RE: Bluewater Mill Site Reclamation Completion Report Comments
License No. SUA-1470, Docket No. 40-8902

Response to NRC's Comments

ADDENDUM 1
RESPONSE TO NRC COMMENTS

Figure 6-6 Ra226 Concentration in Soil Samples taken South of Exen

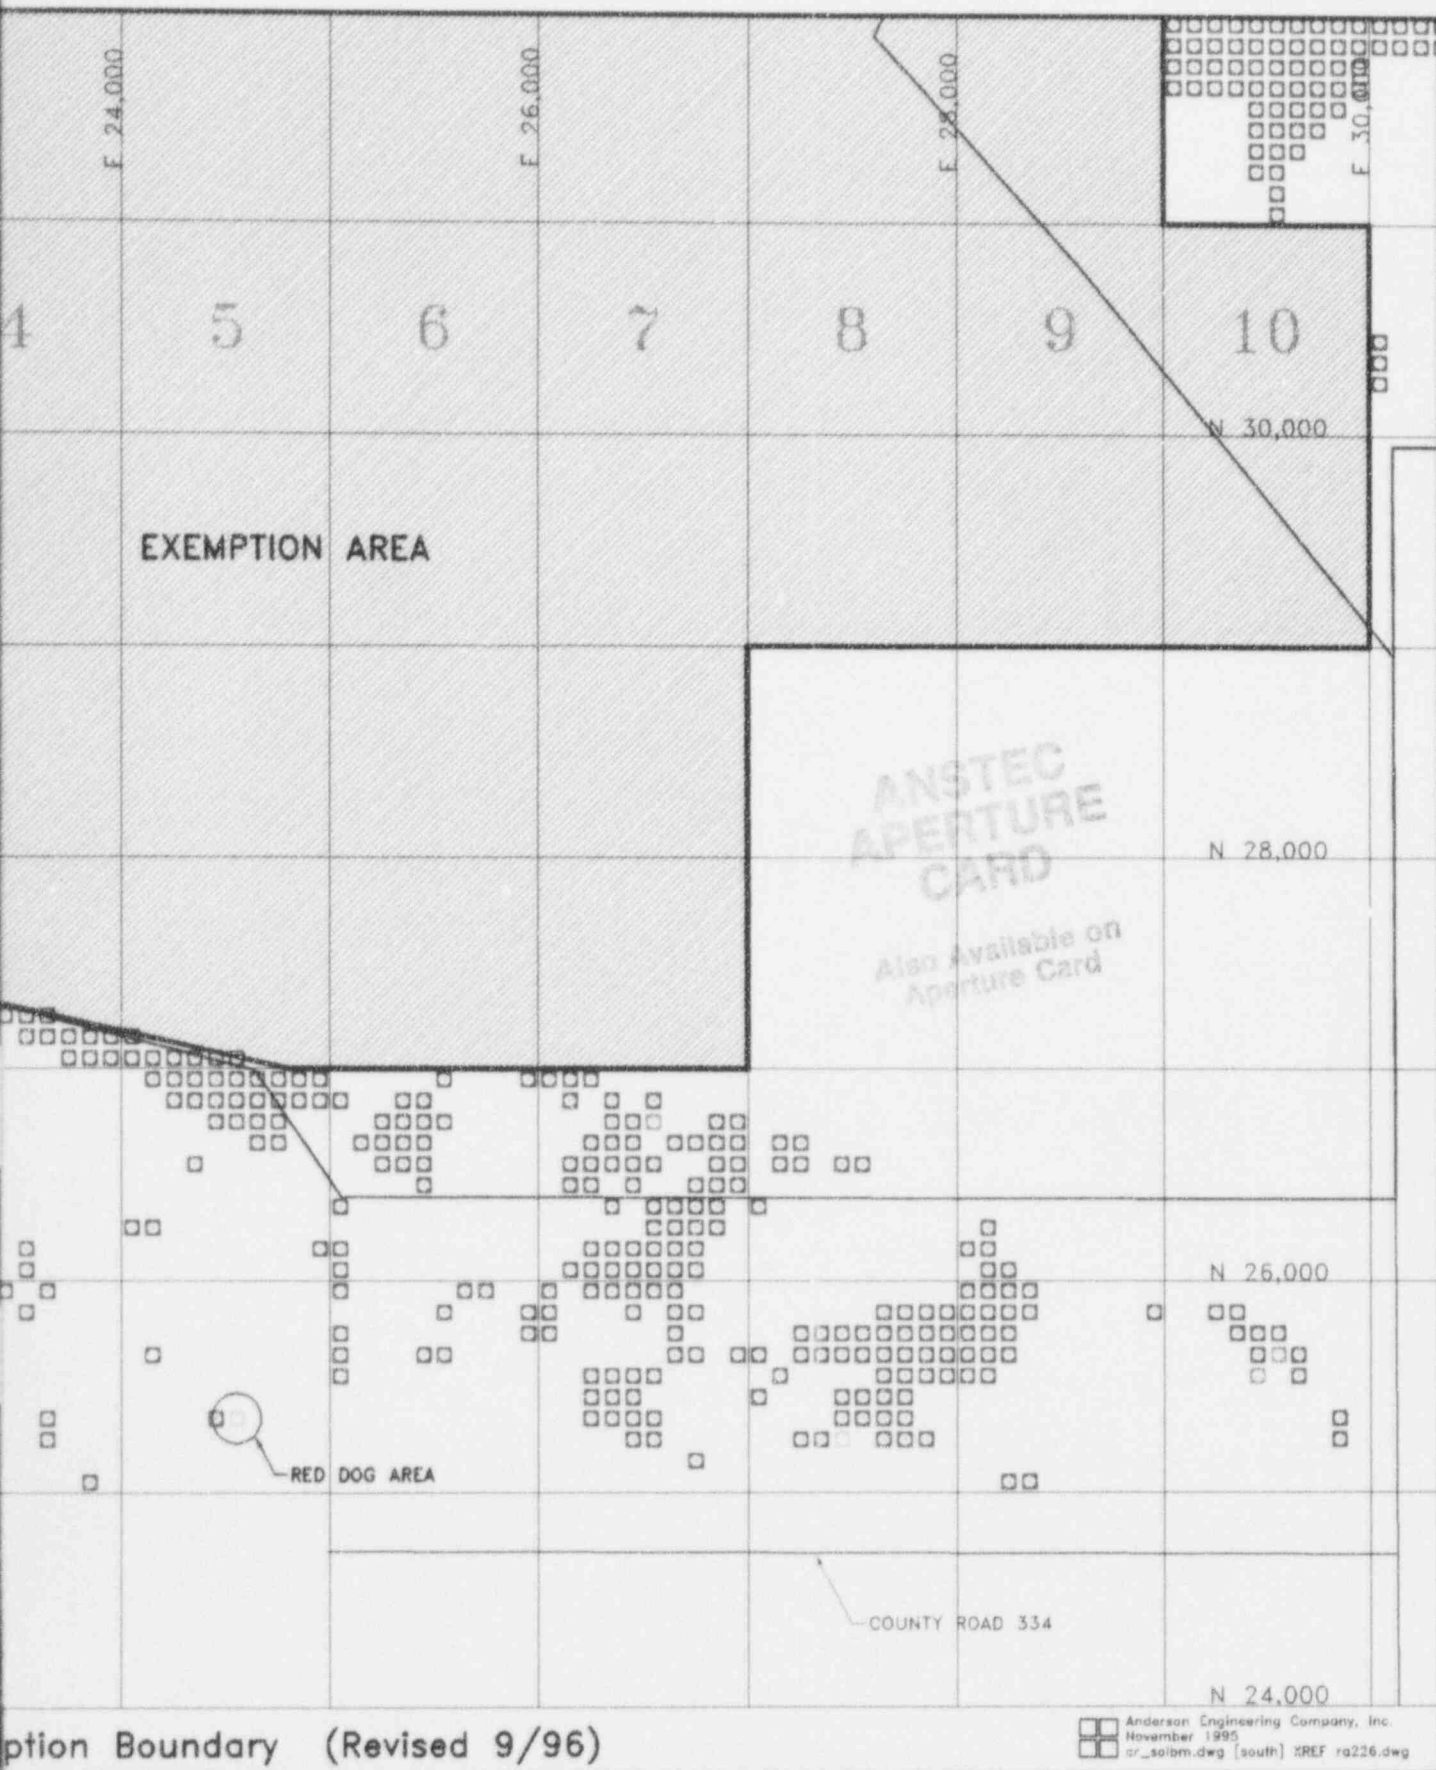
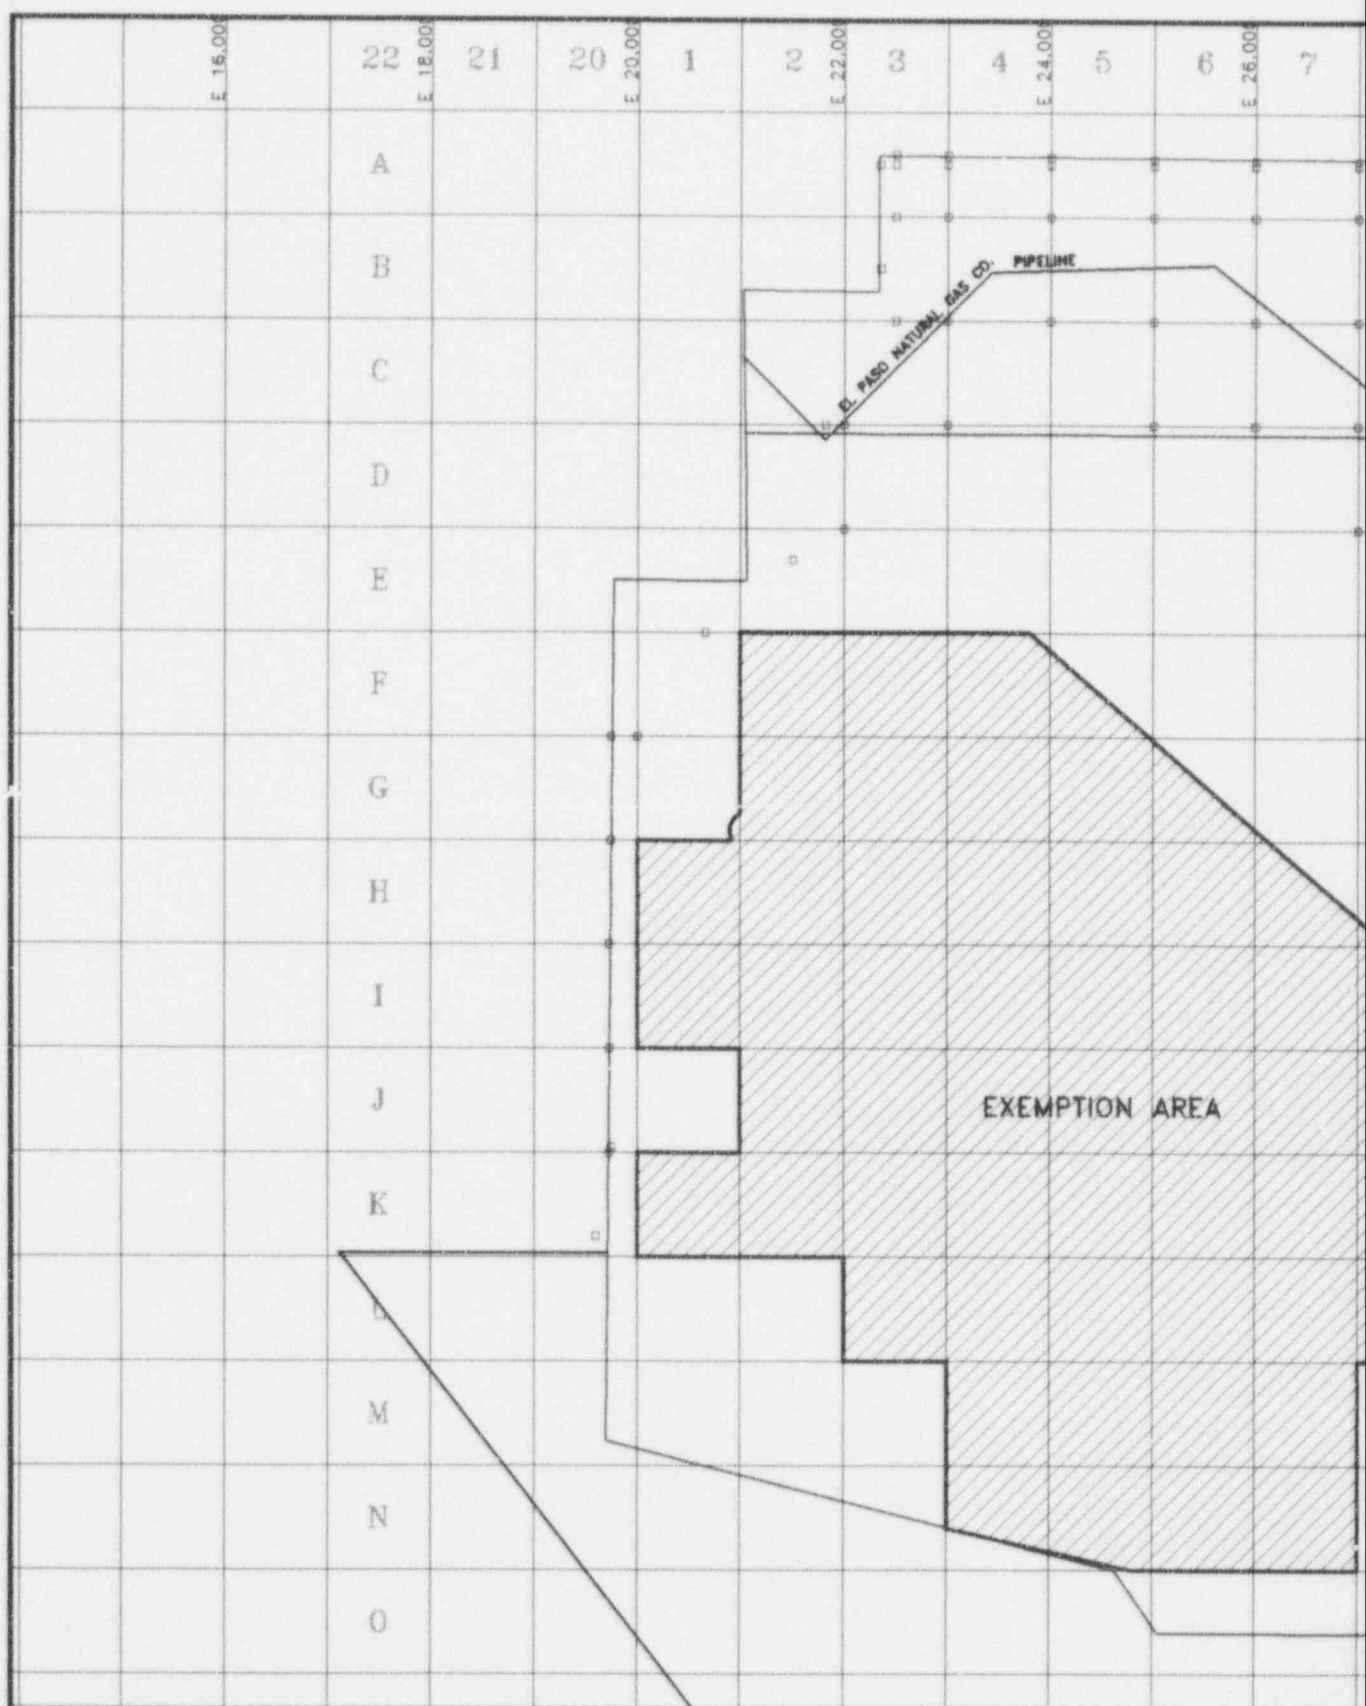
The same paragraph also indicates that Figure 6-6 shows that all Ra-226 measurements are below 6.9 pCi/g, but ARCO should explain why Figure 6-6 indicates 5 grids have Ra-226 values above 6.9 pCi/g (supported by Appendix J elevated values in grids 07-8-8, P5-18-8, P8-18-26, P10-8-29, and P10-13-11).

Comparing Figure 6-6 to Appendix J Ra-226 data, it appears that grids N4-16 to 20, with values of 11.6 to 7.5 pCi/g, should be outside the exemption zone and on the figure. Similarly, grids N5-21 to 23, with values of 33.4 to 8.3 pCi/g, should be on the figure. Explain why Figure 6-6 appears incomplete, or provide a corrected figure.

In all but five cases, the soil samples for the grid blocks indicated that the Ra-226 criterion was met. For the remaining five grid blocks, the soil was removed to bedrock and the small amount of residual soil sampled and analyzed. For those locations (07-8-8, P5-18-8, P8-18-26, P10-8-29, and P10-13-11), the Ra-226 concentration did not meet the cleanup criteria. However, since the area was rocked out, no additional remediation was practical.

Using a larger scale map, we have reviewed the locations of grid blocks N4-16 through N4-20 and find the soil sampling location designations correct as plotted on the map. This also applies to grid blocks N5-21 to N5-23. The presentation may be somewhat deceptive in that the soil sampling grid is a 33.3' by 33.3' grid block centered in each quadrant. However, the presentation on the maps indicates that this represents an area of 100' by 100'. The computer selected the samples on the basis of whether the 33.3' by 33.3' grid block that was sampled was within the boundary.

Figure 6-7 Ra-226 Concentration in Soil Samples taken in Outlying Area

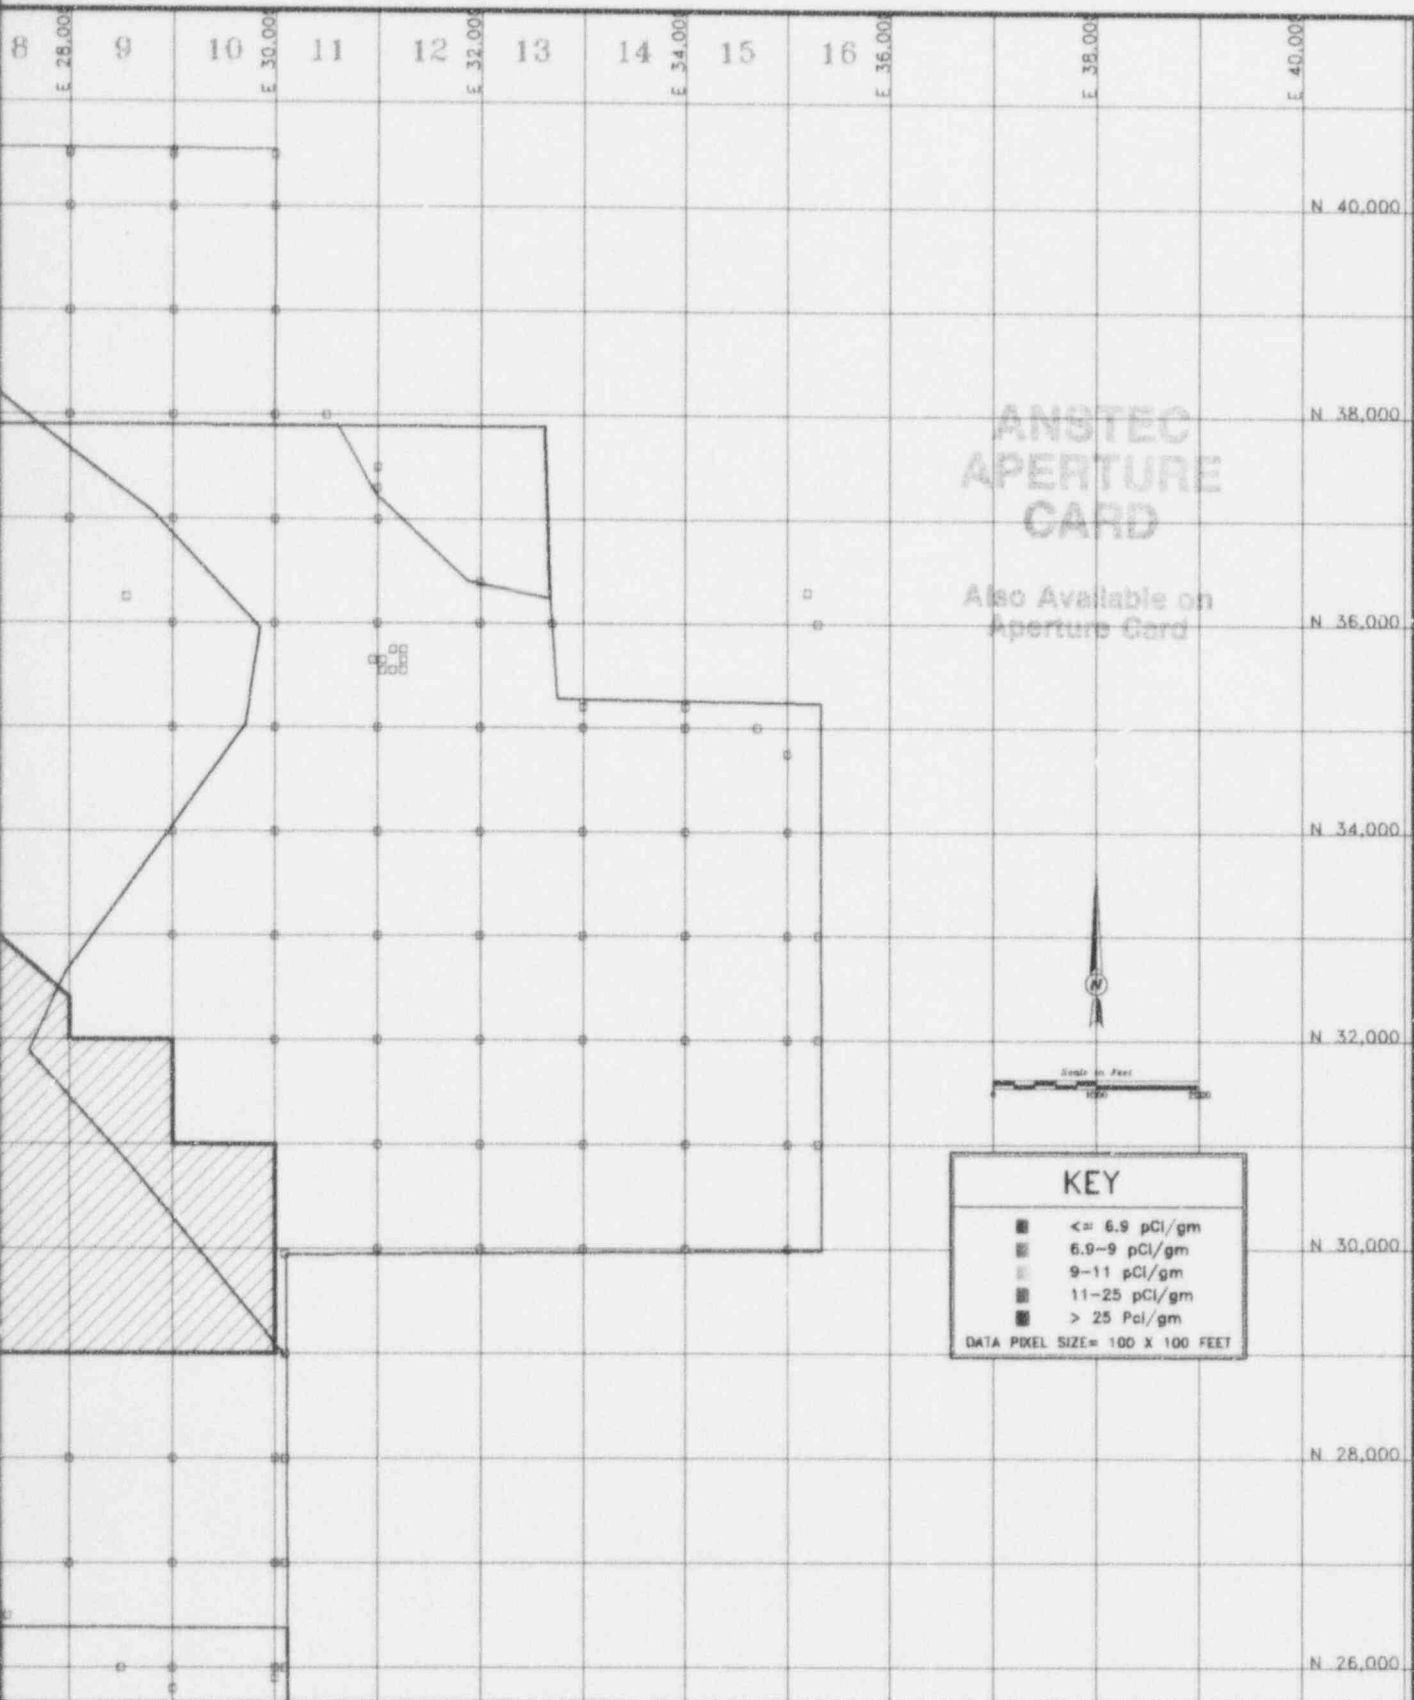
Page 83 discusses verification data from the outlying (unaffected) areas where soil samples were taken every 1000 feet (Figure 6-7) and gamma readings every 500 feet (Figure 6-8). Figure 6-7 indicates that no soil samples exceed 6.9 pCi/g, but Ra-226 data at the end of Appendix J (without grid numbers) indicates that 5 samples exceed the guideline. ARCO should explain why these elevated radiation areas were not cleaned.

For the outlying areas (end of Appendix J), there is no Ra-226 value for grid point N38000 E22000, but data are indicated on Figure 6-7.

The outlying area Ra-226 data in Appendix J are difficult to compare to Figure 6-7, because many of the values are not in order by either the N or E coordinate. ARCO should revise the last 6 pages of Appendix J to make the information easier to evaluate by comparison to Figure 6-7.

Ra-226 data, at the end of Appendix J for outlying area, for 5 soil samples which exceed the cleanup criteria are for locations within the Exemption boundary. Figures 6-7 and 6-8 included in Attachment 1 have been revised to include coordinates at the grid block lines to identify the areas.

Figure 6-9 GPS Based Gamma Ray Count Rate Measurements (Revised)

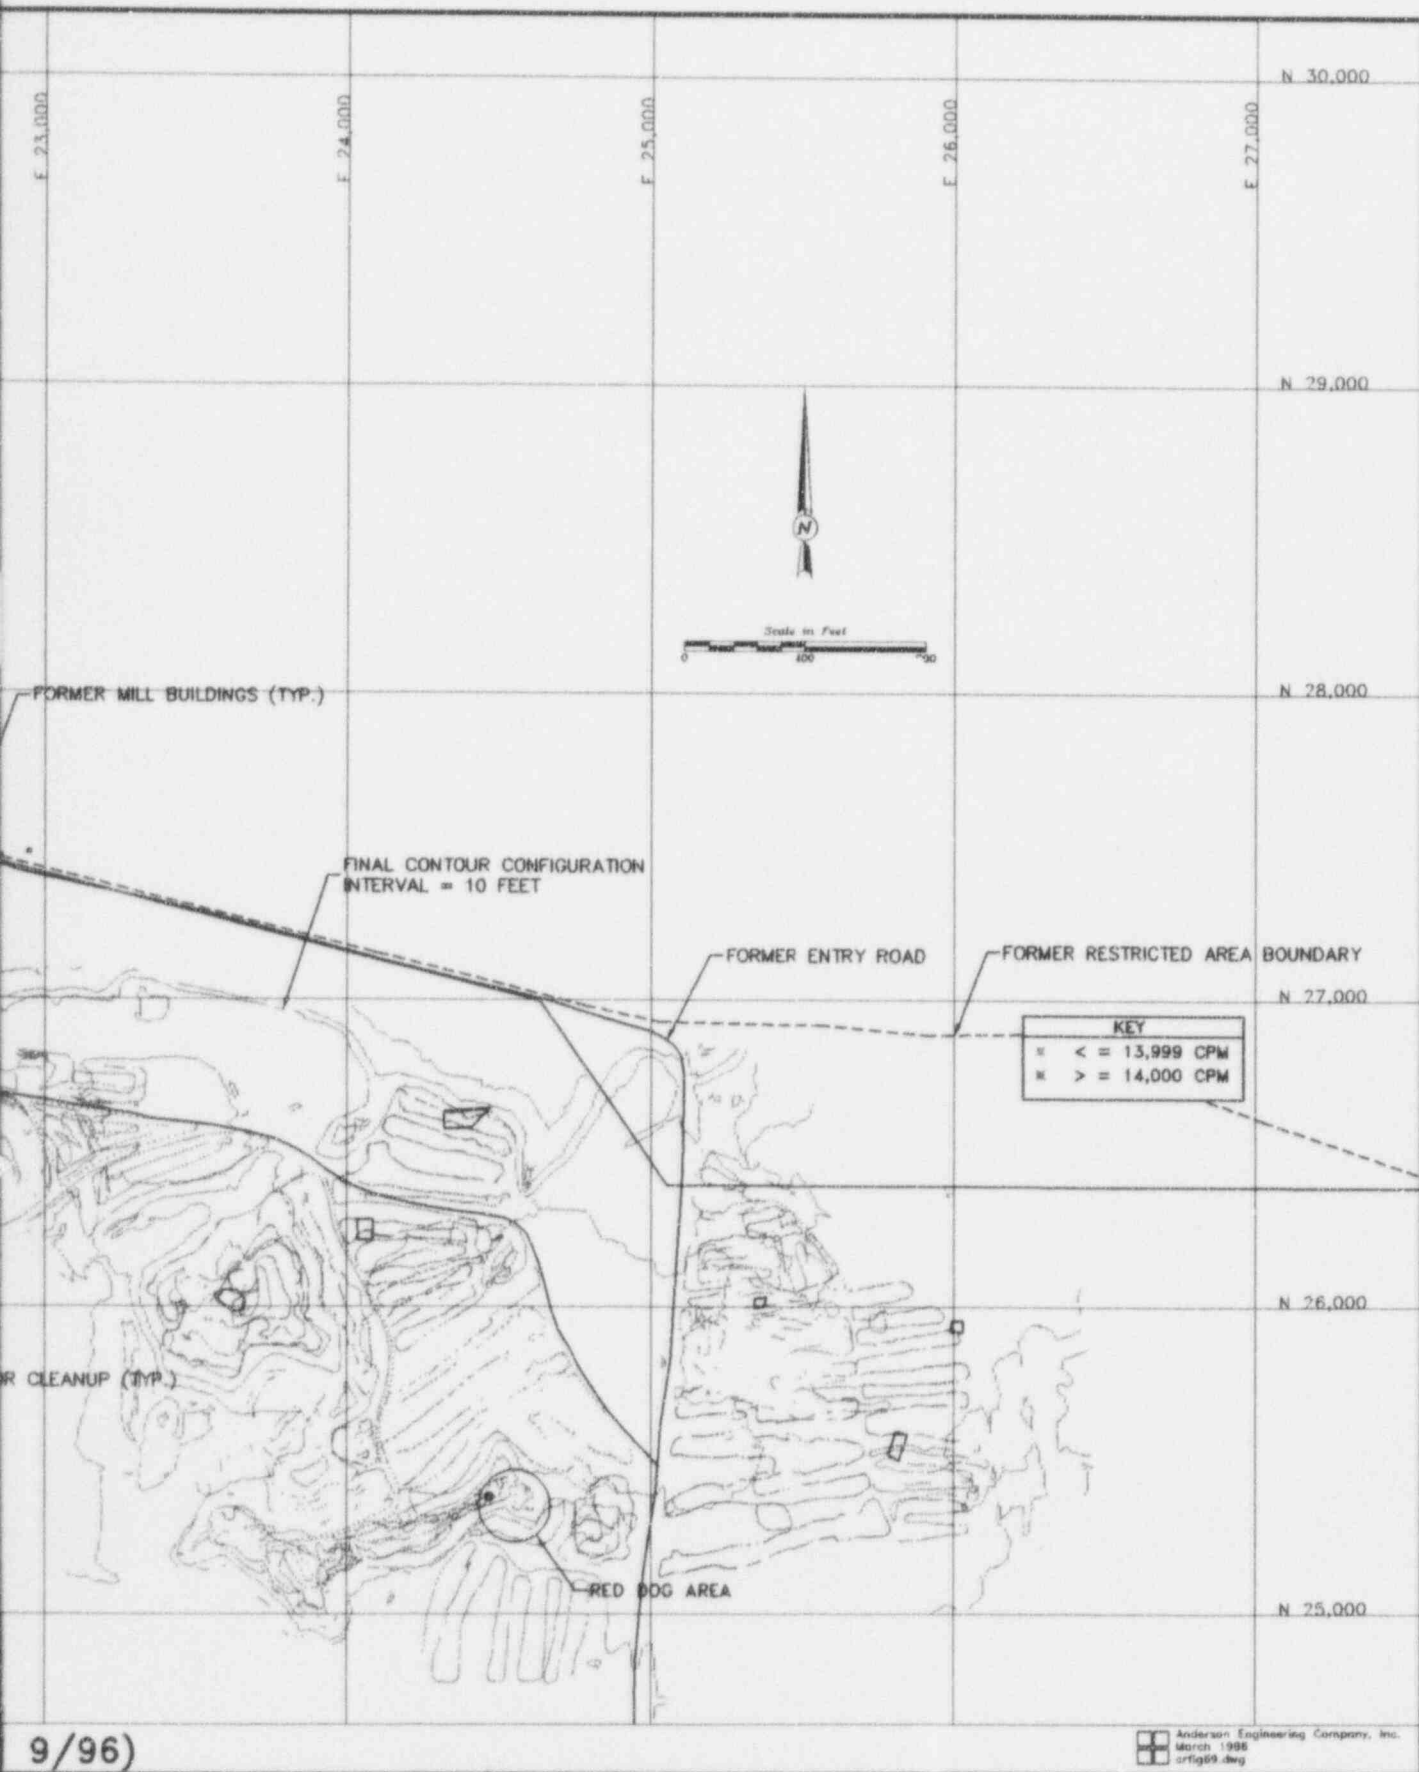
On Figure 6-9, indicate the position of the former golf course, housing areas, county road, and guard station. Also, correct the north coordinate numbers and provide block numbers that correspond to those used on the other figures in Section 6.

Figure 6-9 has been revised and is included in Attachment 1.
